**ZONING AMENDMENT &  
PLANNED UNIT DEVELOPMENT  
STAFF REPORT**

**Date: August 16, 2007**

<b><u>NAME</u></b>	Stratford LLC
<b><u>LOCATION</u></b>	North side of Grelot Road, 160'+ West of Chimney Top Drive West
<b><u>CITY COUNCIL DISTRICT</u></b>	District 6
<b><u>PRESENT ZONING</u></b>	R-1, Single-Family Residence District
<b><u>PROPOSED ZONING</u></b>	B-1, Buffer Business District
<b><u>AREA OF PROPERTY</u></b>	1 Lot / 5.6 + Acres
<b><u>CONTEMPLATED USE</u></b>	<p>Planned Unit Development Approval to allow two buildings on a single building site and Rezoning from R-1, Single-Family Residential, to B-1, Buffer Business, to allow a two-building office complex.</p> <p><b>It should be noted, however, that any use permitted in the proposed district would be allowed at this location if the zoning is changed. Furthermore, the Planning Commission may consider zoning classifications other than that sought by the applicant for this property.</b></p>
<b><u>TIME SCHEDULE FOR DEVELOPMENT</u></b>	Within one year of rezoning approval for the first building, with the second building being undertaken as needed by market demand.

# SITE PLAN

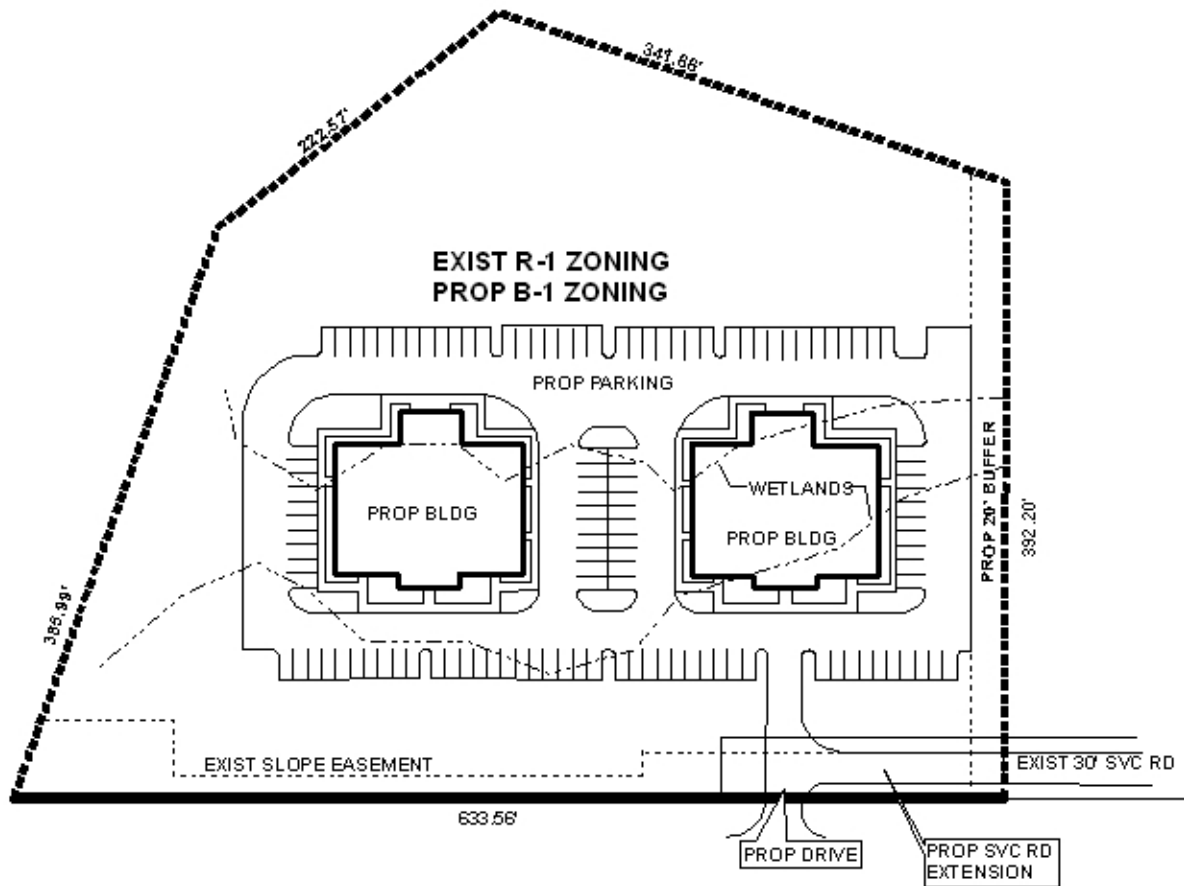
The Zoning and PUD site plans provided for the current application depicts two one-story 11,080 square foot office buildings and 120 parking spaces. The site plan also depicts the extension of the existing service road East of the site onto the property, and one curb-cut onto Grelot Road. It appears that the proposed service road would be private, however it is not clear if this is the case.

Regarding the PUD site plan, the parking requirements in the Zoning Ordinance state that each 11,080 square foot office building would require 37 parking spaces, for a total of 74 spaces. The site plan states that 111 spaces are “required.” The site will exceed the minimum number of parking spaces.

The site plan also shows that the two proposed buildings and parking area will be situated on the wetlands that exist on the site, as well as the primary natural drainage, which goes from the East side of the site to the West side of the site, draining into a branch of Milkhouse Creek. It appears that the development could be redesigned to reduce the impact to the existing wetlands and natural drainage system.

There is no indication on the site plan as to the proposed location of any dumpster or other waste storage facility. If the applicant utilizes a dumpster, the location of the storage area for the dumpster must be indicated on the site plan, and the location and required screening must comply Section 64-4.D.9. of the Zoning Ordinance, as well as with all other applicable regulations.

There is no indication of storm water detention facilities on the site plan, but such facilities will likely be required. The site plan should depict the general location of these facilities.

The site plan does not depict the 30-foot minimum building setback line from Grelot Road, as depicted on the approved preliminary plat. The site plan does depict, however, a 20-foot wide undisturbed natural buffer along the East side of the site, to protect the existing single-family residences to the East.

Regarding the proposed extension of the service road from the East onto the site, it will facilitate the access for the site, but it may increase the traffic volume for the access from the service road to Grelot Road where the service road intersects with Grelot and Chimney Top Drive West (where there is also a break in the median of Grelot Road). The access onto Grelot Road at Chimney Top Drive West is across the street from the entry/exit of an existing apartment development, thus there appears to be a high probability of traffic conflicts at this location. Also, a determination should be made as to whether the "service road" extension will be public or private. If public, the right-of-way should be dedicated to the City of Mobile.

A sidewalk along Grelot Road will be required as part of the development, if approved. The site plan should be revised to show the sidewalk.

The site will have adequate area to meet the minimum requirements for landscape area, as required by the Zoning Ordinance. The site plan does not, however, show specific compliance with the tree requirements of the Ordinance.

- 1) based upon the denied Zoning application; and
- 2) the site plan does not appear to take into account the natural features of the site.
